**PERRY NUCLEAR POWER PLANT**

February 22, 1994  
PY-CEI/NRR-1694 L

Perry Nuclear Power Plant  
Docket No. 50-440  
Supplement to Technical Specification  
Change Request: Increase Surveillance  
Test Intervals and Allowable Outage  
Times for Instrumentation (TAC M84057)

FIGURE 1

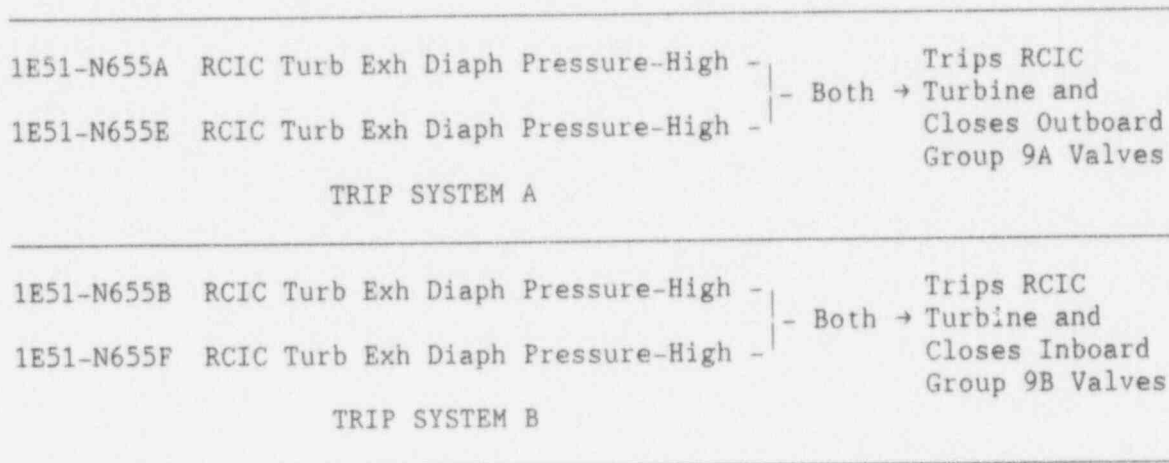
The loss of function concern discussed above could be experienced, for example, during repairs of instruments for a Function which has a logic configuration consisting of two trip systems, each of which has a two out of two logic. If one of the instruments in one trip system is inoperable, the logic for that trip system cannot be completed since both

instruments are required to operate, and if the other trip system that provides the same Function also contains one inoperable instrument, a "monitoring" capability is still maintained in both trip systems, but the capability to perform the Function has been lost (see Figure 1).

Using the previously proposed Action statements (from the June 29, 1992 amendment request), this "loss-of-function" condition could theoretically exist for up to 24 hours without any compensatory actions required, if multiple instruments were to become inoperable simultaneously. The revisions to the Action statements that are proposed below will alleviate this concern by ensuring that when instruments for a particular Function become inoperable, operators will perform checks to verify that the Function maintains its capability to complete its safety-related purpose. If it cannot, sufficient channels will be placed in the tripped condition to allow for completion, unless such action would cause the trip function to occur unnecessarily. In such cases, the associated system will be declared inoperable and appropriate required actions taken.
